ADDENDUM NO. 8

Reference: Holland Centennial Commons
Dixie State College – St. George, Utah
DFCM Project No. 06297640

ADDENDUM #8

PROJECT:	**Dixie State College of Utah** **Holland Centennial Commons**	**ARCHITECT'S PROJECT NO:**	09625
		No. Pages:	38 pages
OWNER:	Dixie State College	**DATE:**	January 6, 2011
ARCHITECT:	VCBO Architecture	**GENERAL CONTRACTOR:**	
SUBMITTAL DATE:	January 19, 2011	**SUBMITTAL TIME:**	12:00pm

Addendum #9
C2 Sheet A510

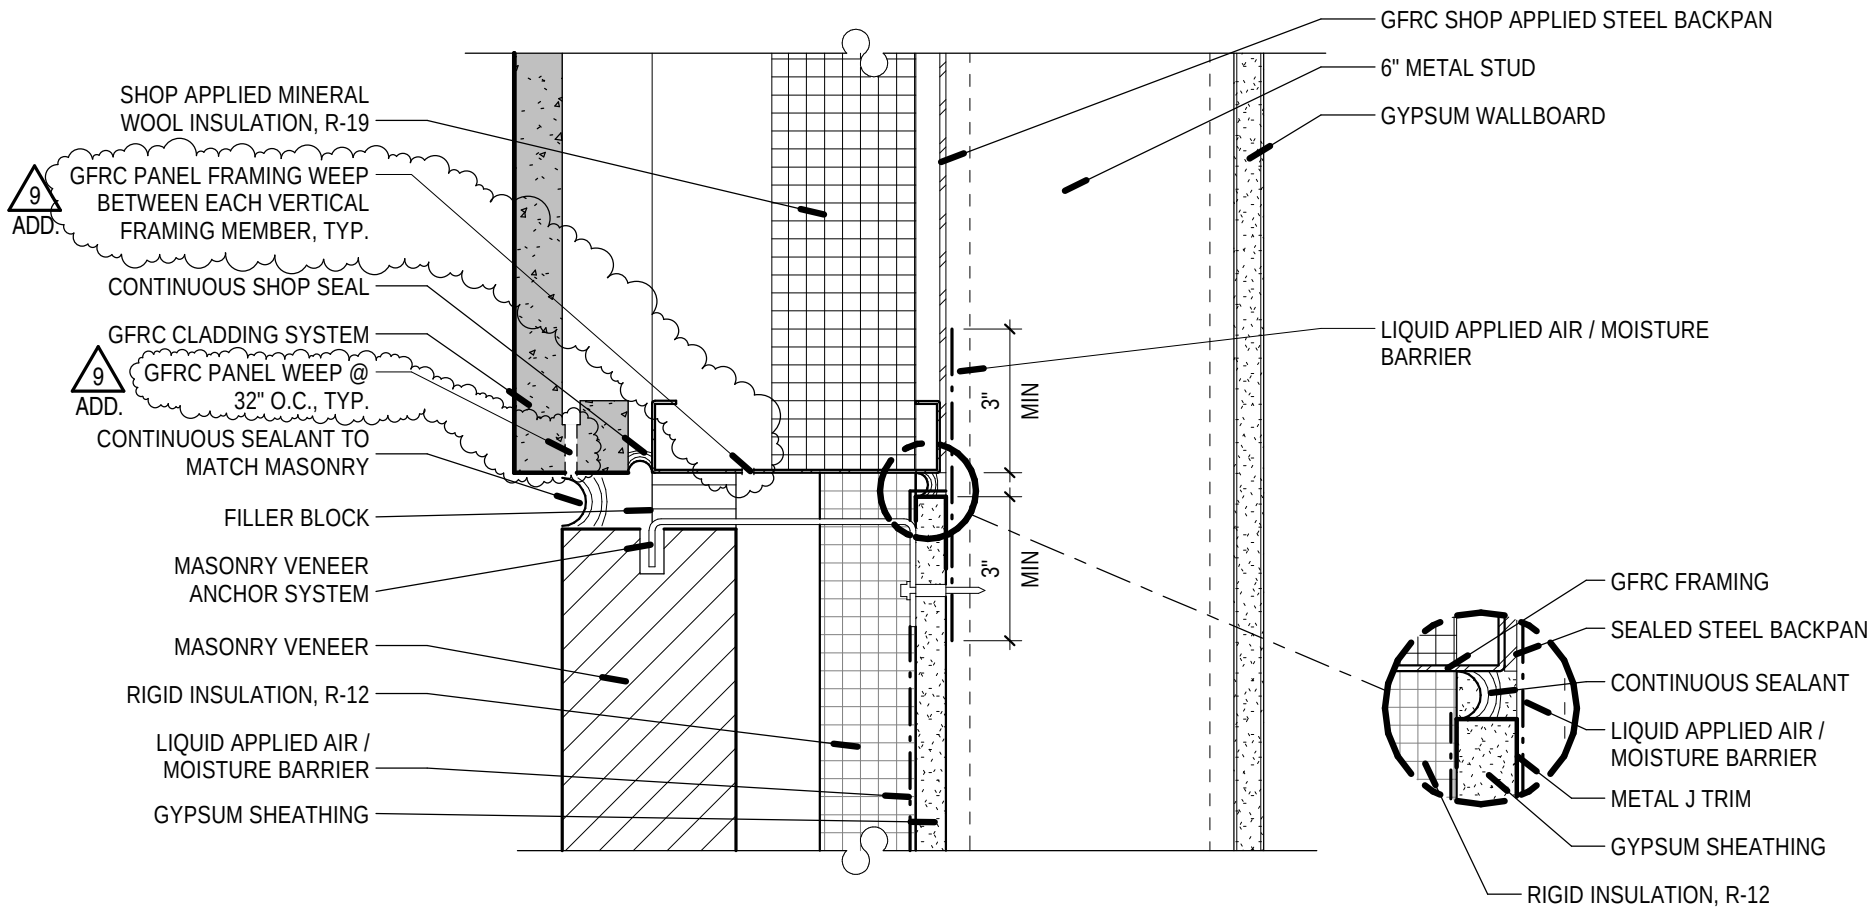
1. See attached revised detail C2/A510.

Addendum #9
D3 Sheet A553

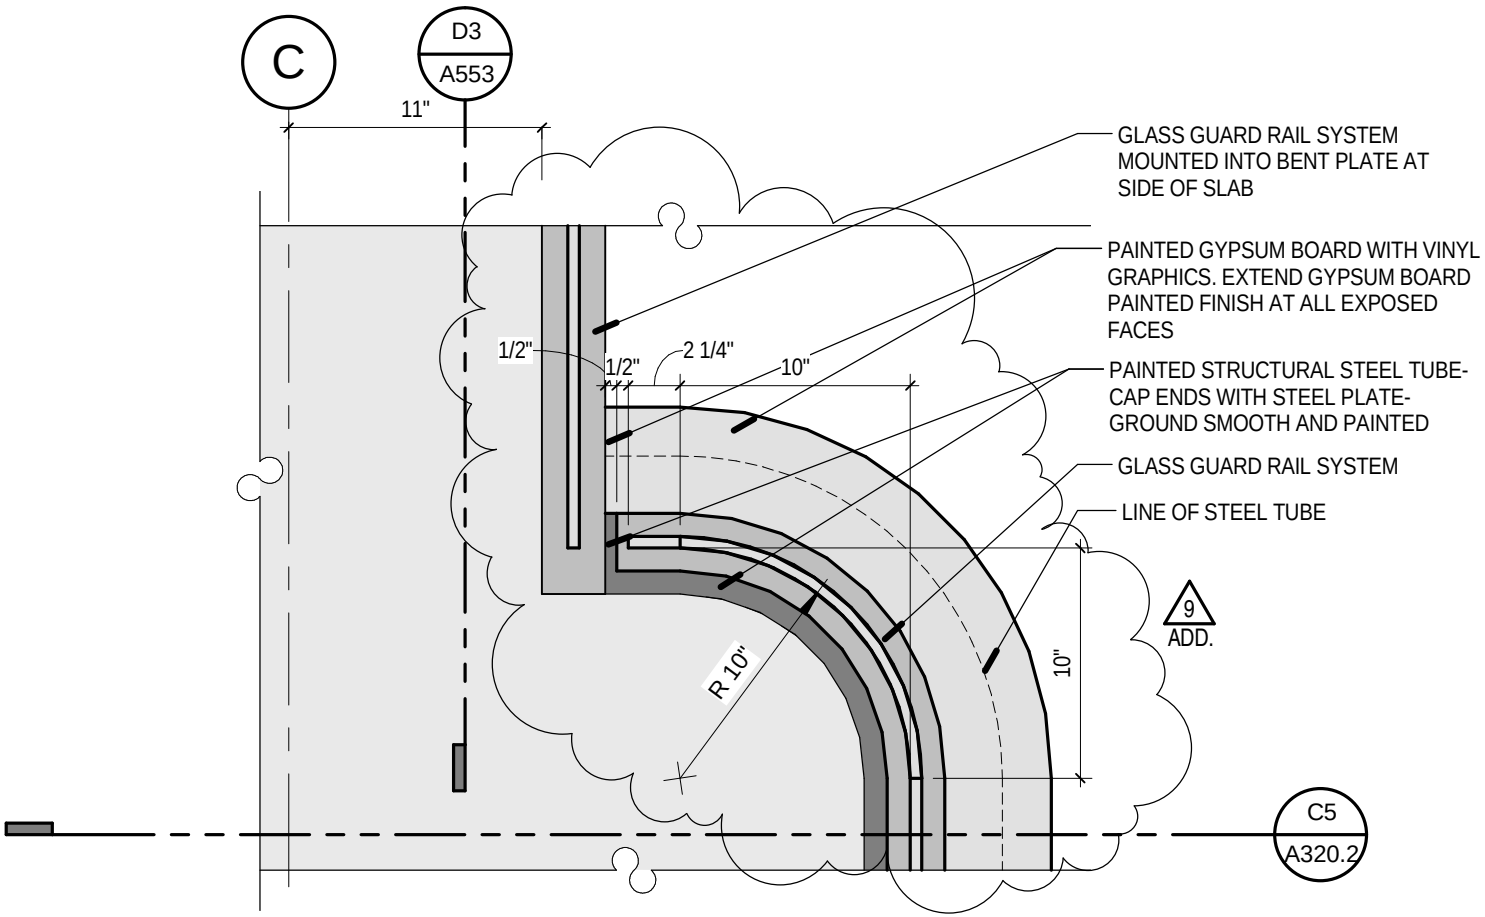
1. See attached for revised Detail D3, dimensioning the curved glass.

EP104
Sheet Number

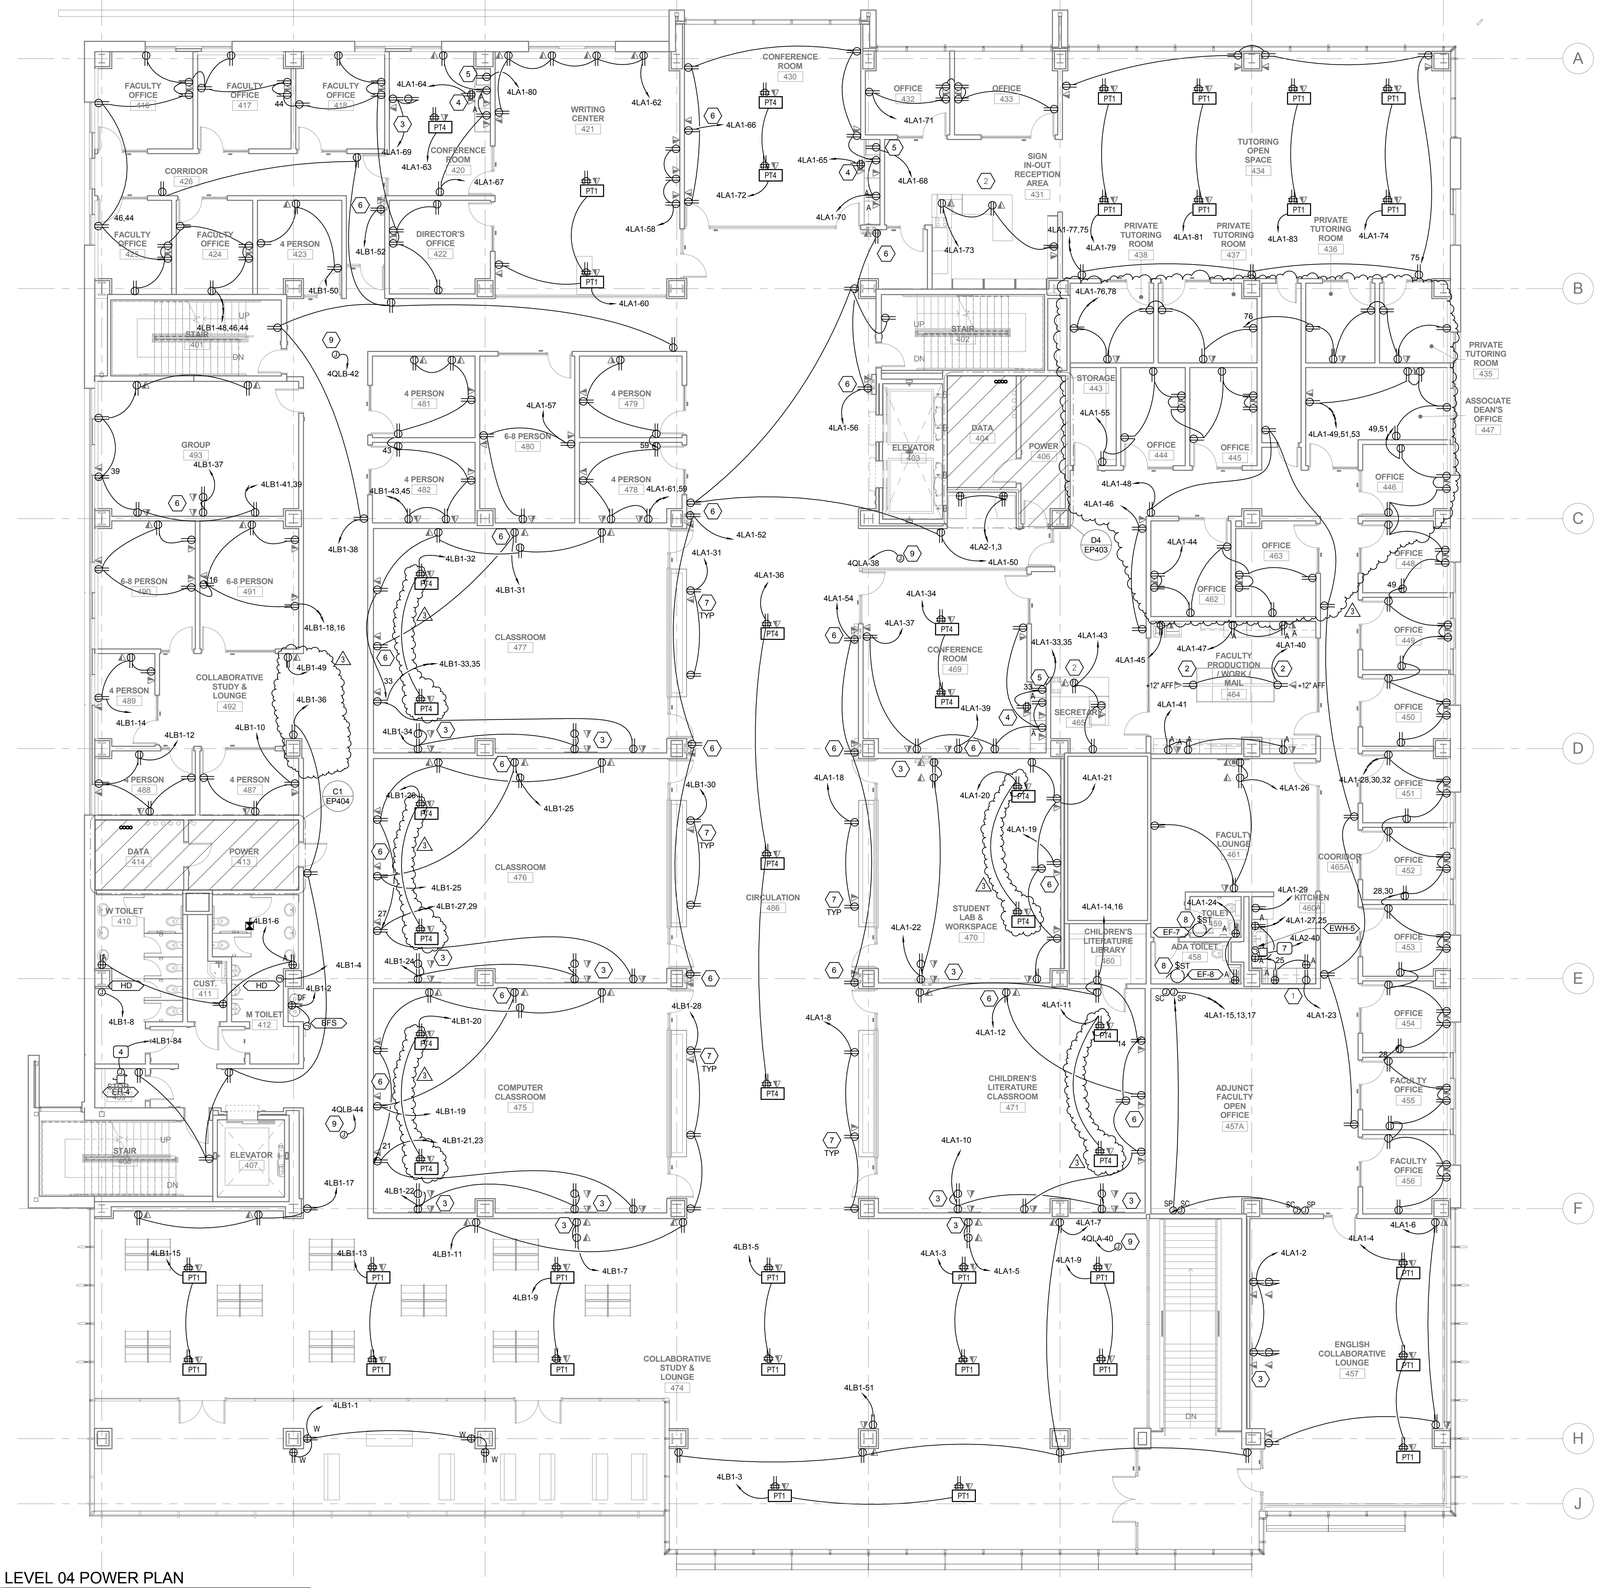
1. Refer to attached full size sheet EP104 for changes described below.

A1 LEVEL 1 LIGHTING PLAN

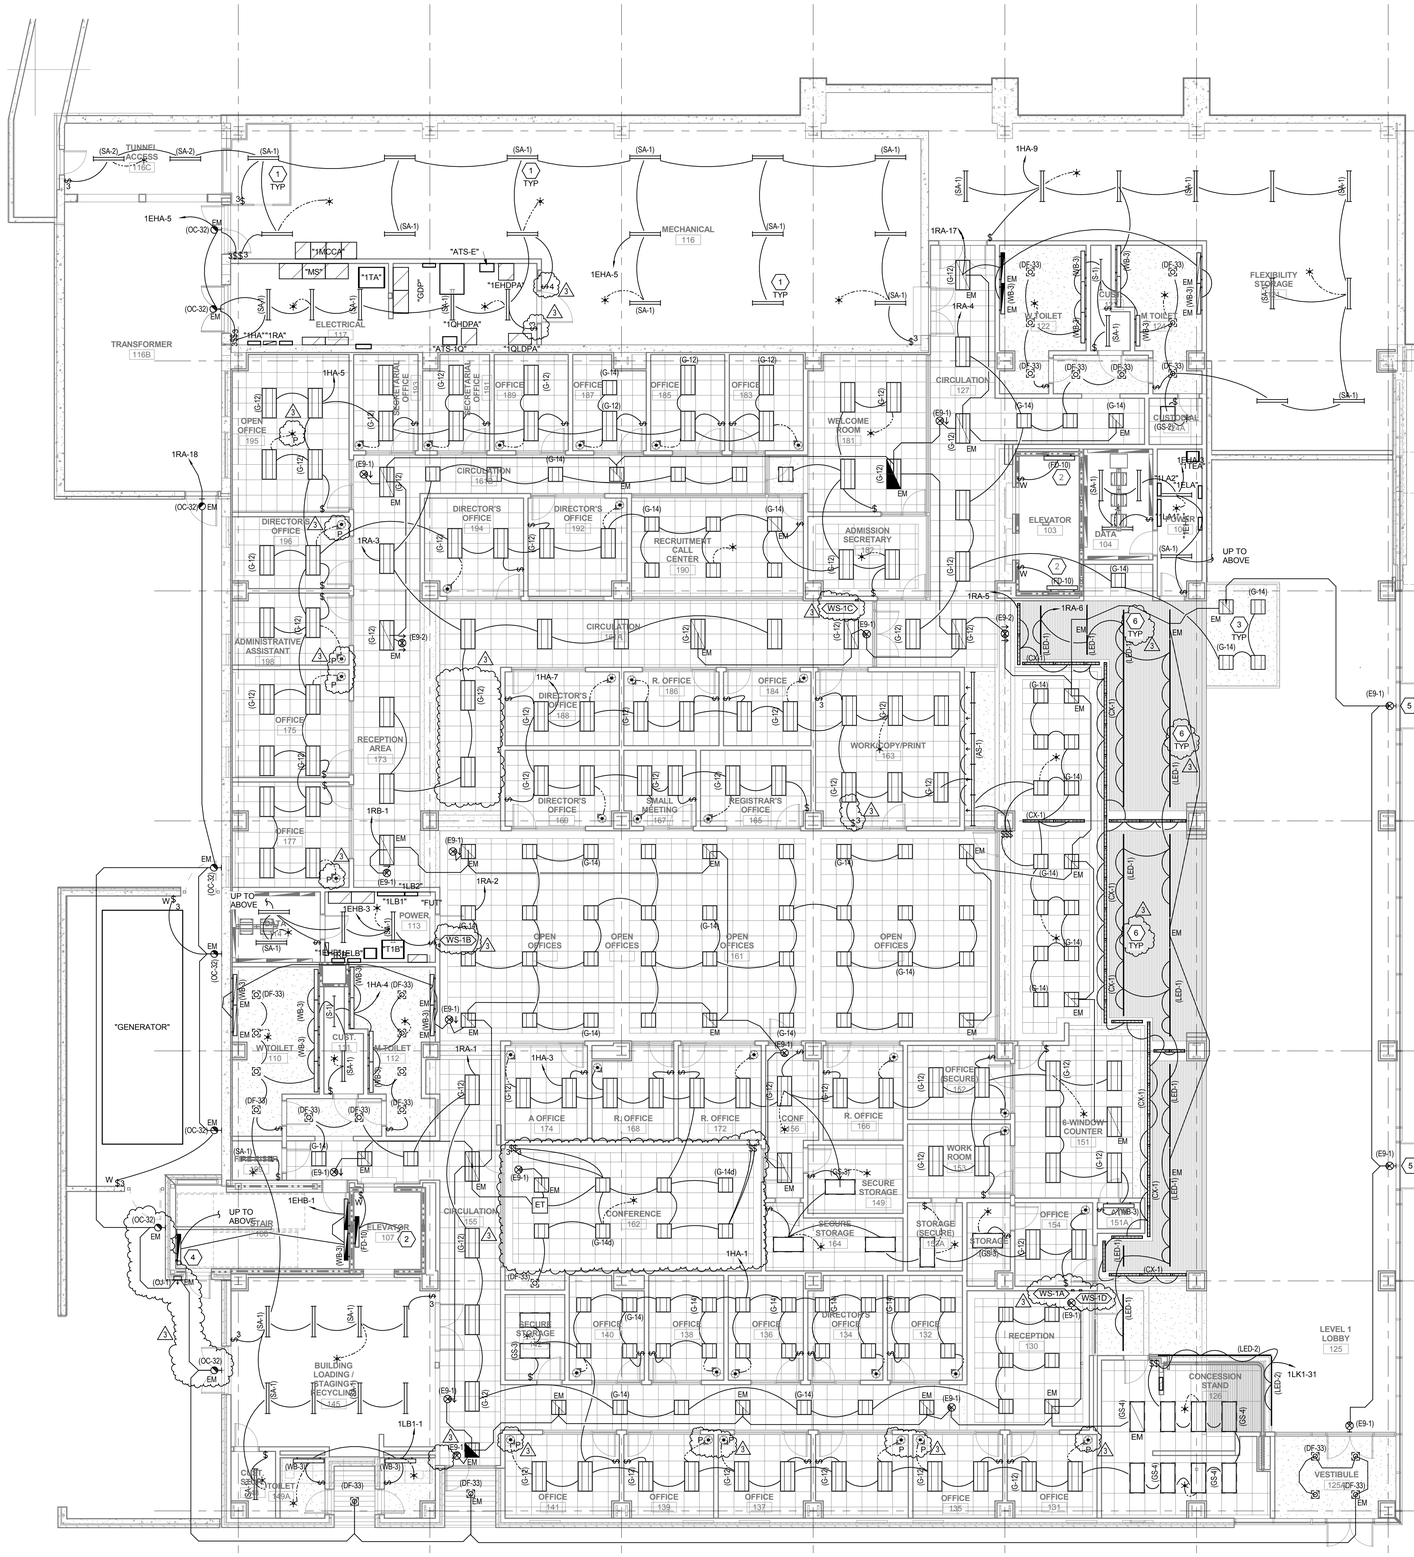
1. Refer to attached full size sheet EL101 for changes described below.
2. Relay override wall station identifier text for WS-1A, WS-1B, WS-1C and WS-1D has been turned on.
3. Text identifiers for photo-responsive occupancy sensors have been turned on. All enclosed spaces with an exterior window shall have photo-responsive occupancy sensors.
4. Add one OJ-1 type fixture near exterior door exiting Stair 108.
5. Fixtures in Conference 162 are type G-14d.
6. Add 3-way switch Work Room 163 and change the other switch in that room to 3-way.
7. Add 3-way switch identifier to switch at east door of Electrical 117.
8. Add 4-way switch identifier to switch in Mechanical 116 at door to Electrical 117.
9. Add sheet keynote #6 text: "Fixtures mounted between wood ceiling slats. Provide support from structure above.
10. Add sheet keynote #6 at LED-1 fixtures between grids C and F and grids 5 and 6.

EL102
Sheet Number

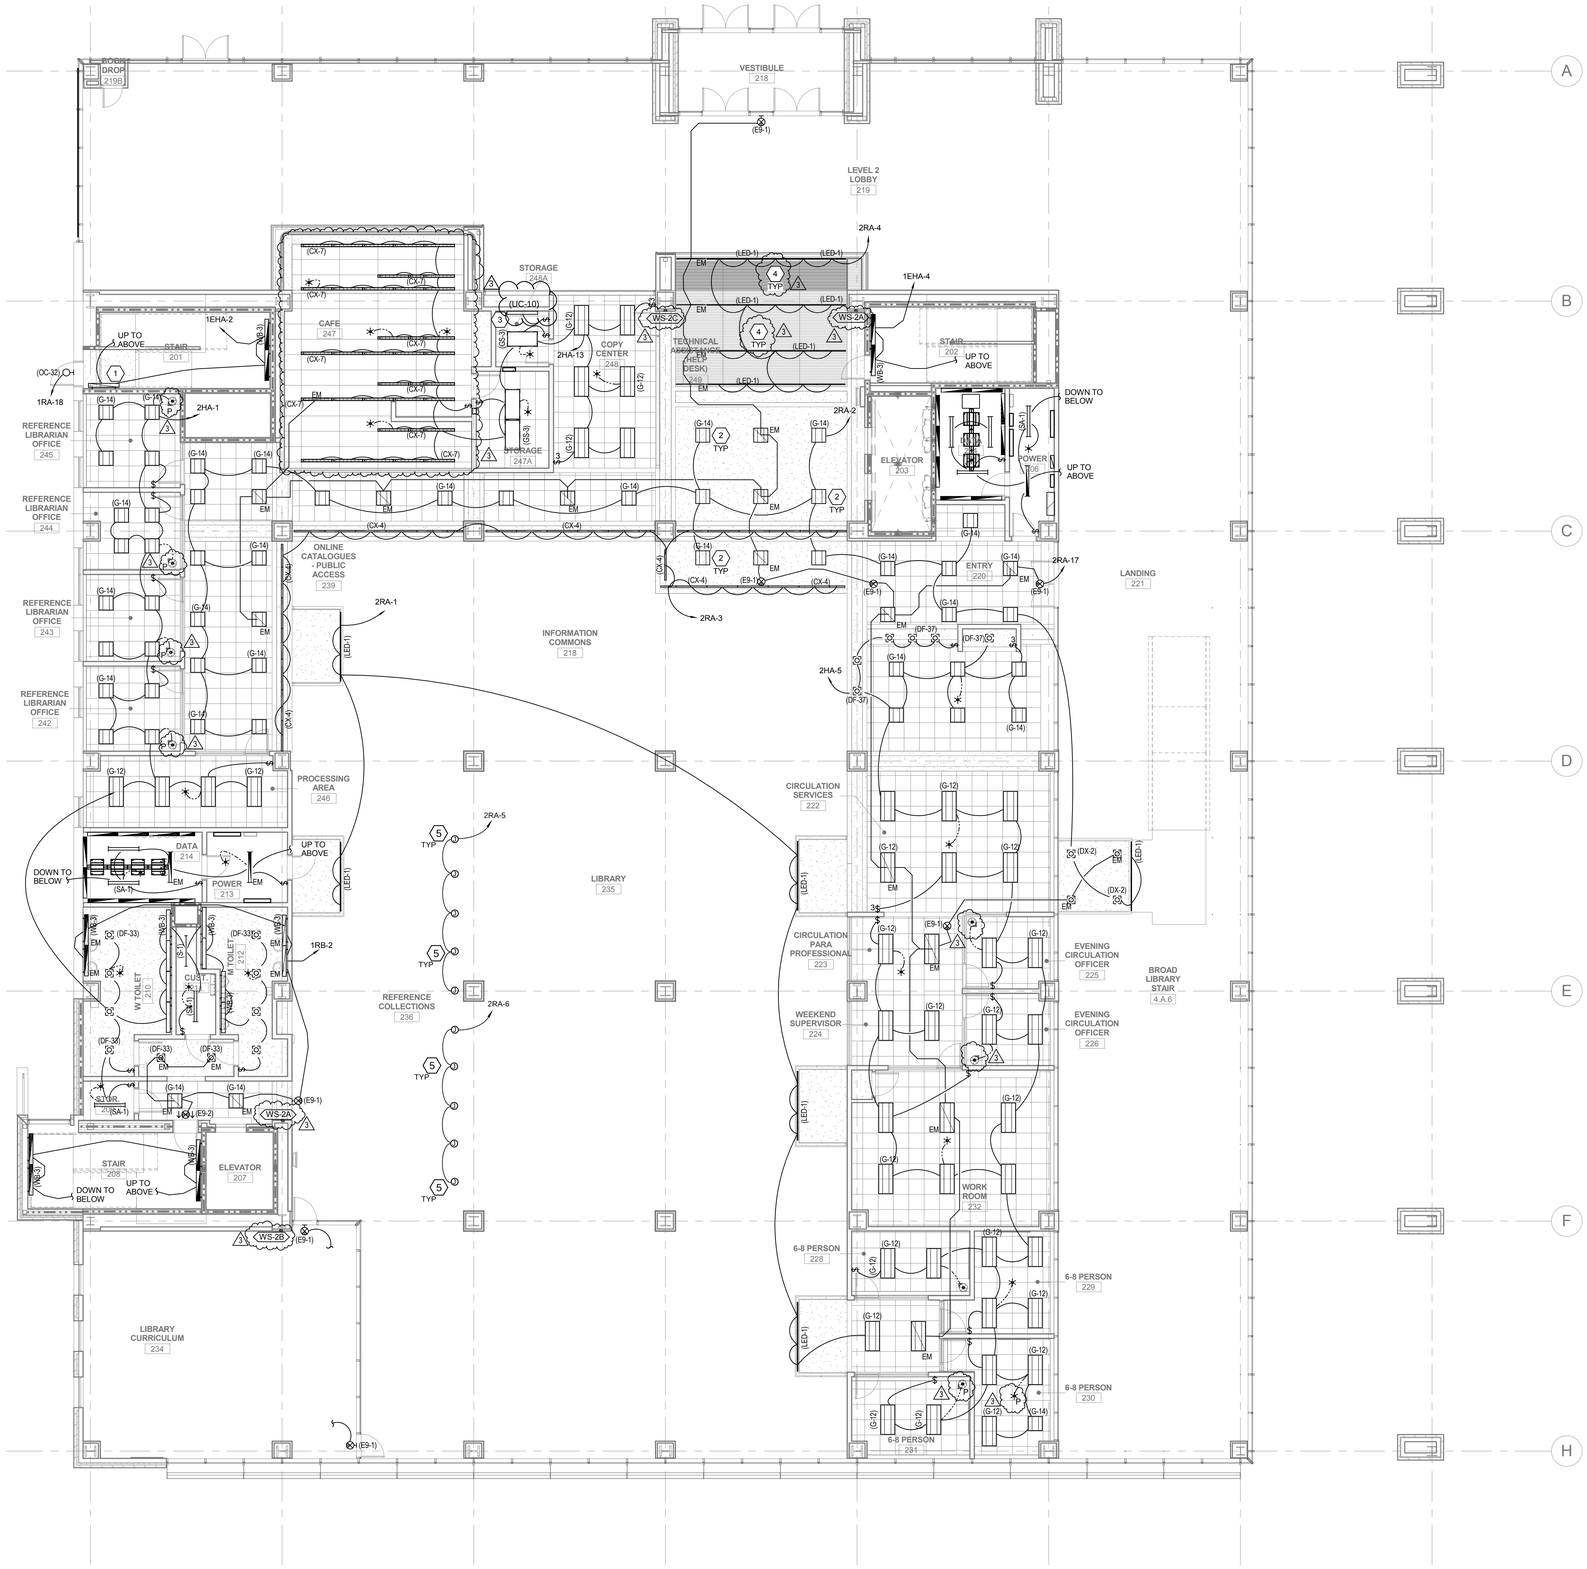
1. Refer to attached full size sheet EL102 for changes described below.
2. Relay override wall station identifier text for WS-2A near grids B-5 and E.5-2 has been turned on.
3. Text identifiers for photo-responsive occupancy sensors have been turned on. All enclosed spaces with an exterior window shall have photo-responsive occupancy sensors.
4. Add sheet keynote #4 text: "Fixtures mounted between wood ceiling slats. Provide support from structure above.
5. Add sheet keynote #4 at LED-1 fixtures between grids A.7 and B.5 and grids 4 and 5.
6. Fixtures in Storage 247A are type GS-3.
7. The unidentified fixture in Storage 248A is type UC-10.
8. The lighting layout and fixture types in Café 247 have been updated.
9. Occupancy sensors in offices 225 and 226 are not the photo-responsive type.
